## **Southwest Light Rail Transit: Kenilworth Shallow LRT Tunnels Water Resources Evaluation**

**Metropolitan Council**

**Project No. 76701**

**March 18, 2014**

Figure 2: Construction Sheet Pile Cell

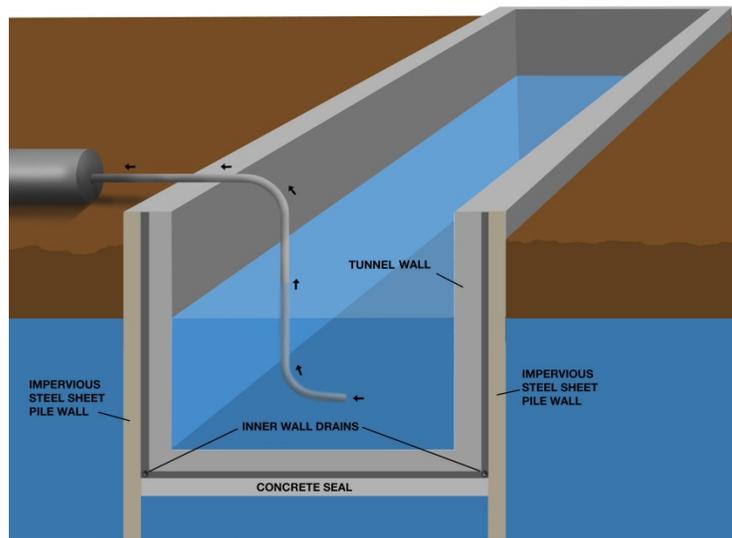
- Based on our understanding of the proposed construction method, the Cell 1 (Excavation) dewatering calculation would not apply because no pumping of groundwater would occur until after the excavation is complete and the concrete seal is in place. At that point the Cell 2 (Construction) scenario would apply.

- Although sealed sheet piling joints are proposed in the BODR, the analysis for groundwater control during construction of the excavation cells appears to assume open joints as stated in the BODR construction sequence.

- The calculation for groundwater removal in the excavation cell factors in the seepage rate for each sheet piling joint, the total number of joints, and the maximum precipitation anticipated to occur during the 15-day construction period. Additionally, this calculation factors in the volume of the cell that is below lake level during the 15-day period. However, when this volume is factored into the calculated pumping rate for the excavation cell a 45-day period is assumed. Groundwater removal from the excavation cell will occur in 15 days as that is the length of time the cell will be under construction. If the 15-day excavation cell period is substituted in place of the 45-day period, the resultant pumping rate is 24.6 gpm, rather than the 10 gpm reported in the BODR.

- For the Cell 2 (Construction) calculation (in which the sheet pile joints will be sealed) a joint resistance of  $1.0 \times 10^{-7}$  m/s is used. A joint resistance of  $3 \times 10^{-10}$  m/s should be used (according to the referenced sheet pile manual). When this factor is applied in the spreadsheet calculation, a pumping rate of 0.6 gpm is the result, rather than 2.4 gpm presented in the BODR.

It is recommended that these rates be thoroughly re-evaluated with clearly stated assumptions, input values, and ranges of calculated values. Additionally, the anticipated long-term performance of the waterproofing system should be evaluated considering its durability and other projects where this system has been used in similar settings.

Figure 6: Groundwater Piezometer Data (Voyen, 2013)

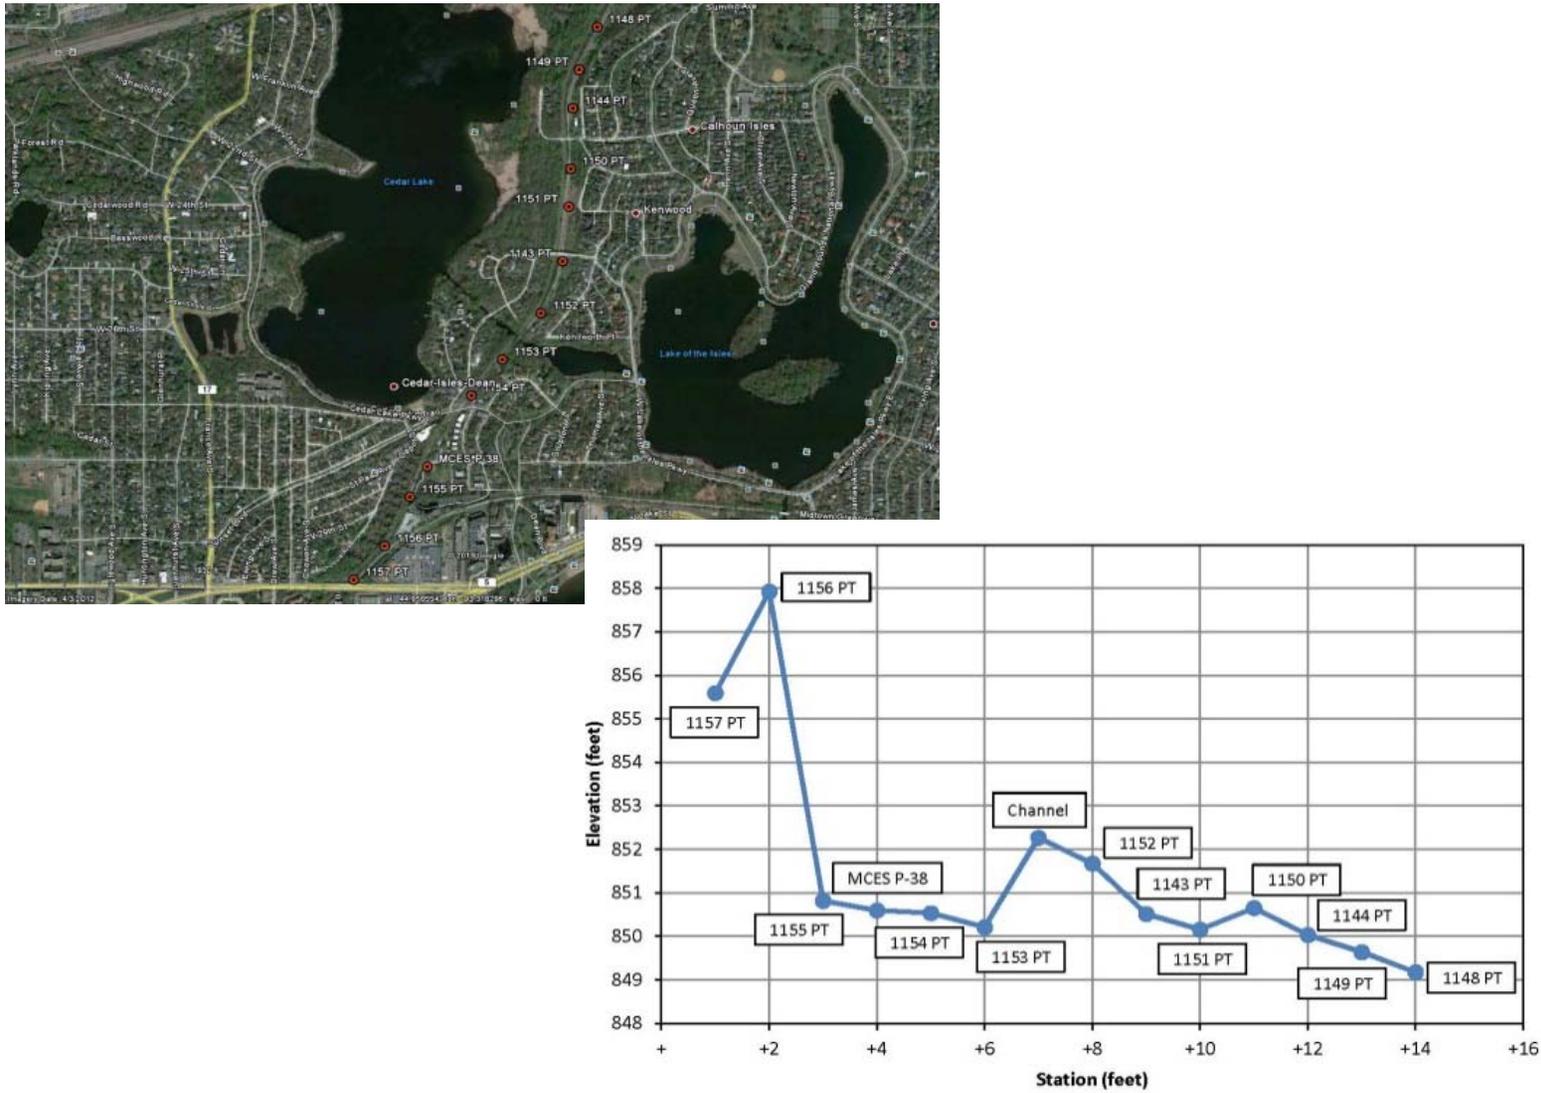
Since the AET piezometers are installed only along the proposed route in the Kenilworth Corridor, they only provide a one dimensional view of the groundwater elevations and it is difficult to conclusively determine the groundwater flow pattern. Additional piezometers lateral to the proposed route are needed to better characterize the groundwater flow system in two dimensions, and a few nested piezometers completed at a greater depth would help to evaluate potential downward flow. Also, the water levels presented in the BODR are only from October and November 2013. Seasonal water level data are needed to better understand groundwater elevations during wet periods and in response to rain events.
